| TO: Mercedes-Benz Principals, General Managers,<br>Sales Managers, Service Managers, Parts<br>Managers        | FROM: Anthony Washington, Department<br>Manager, Regulations and Certifications |
|---|---|
| Re: Recall Campaign Launch Notification Model 907 (Sprinter) Model Years 2021 Tighten Spring Loaded Rear Step | DATE: February, 2022  |

Recall Campaign Bulletin

Campaign No. 2022010007, February, 2022

**Tighten Spring Loaded Rear Step**

D88.30-A047-79

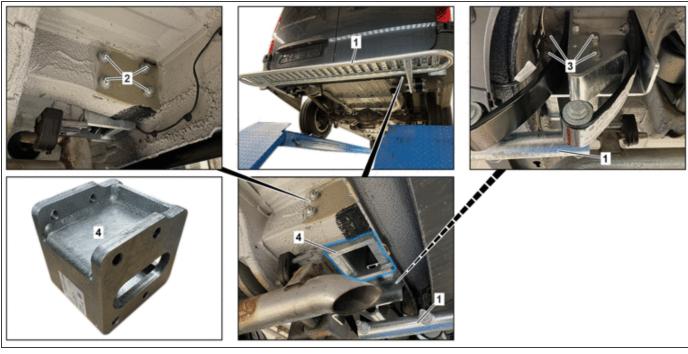
| Important!  |
|---|
| The following operation steps are to be performed on the right side of the vehicle. |

| ⚠Danger     | Risk of death caused by vehicle slipping or toppling off of the lifting platform. | Align vehicle between vehicle lift columns and position the four support plates at the vehicle lift support points specified by the vehicle manufacturer. | AS00.00-Z-0010-01A                    |
|-------------|---|---|---------------------------------------|
| 3           | Support spring-mounted step (1).  |   |                                       |
| ₩S<br>4     | 000 588 11 62 00 Major assembly   | To do so, remove screw/bolts (2, 3). Replace screws (2, 3) too.  Screw/nut, sprung running board to longitudinal member                                   | WS01.00-P-0092B  BA88.30-Z-1001-03KTS |

| Number               | Designation                                     | Model 907, 910 |
|----------------------|---|----------------|
| BA88.30-Z-1001-03KTS | Screw/nut, sprung running board to longitudinal | 94Nm           |
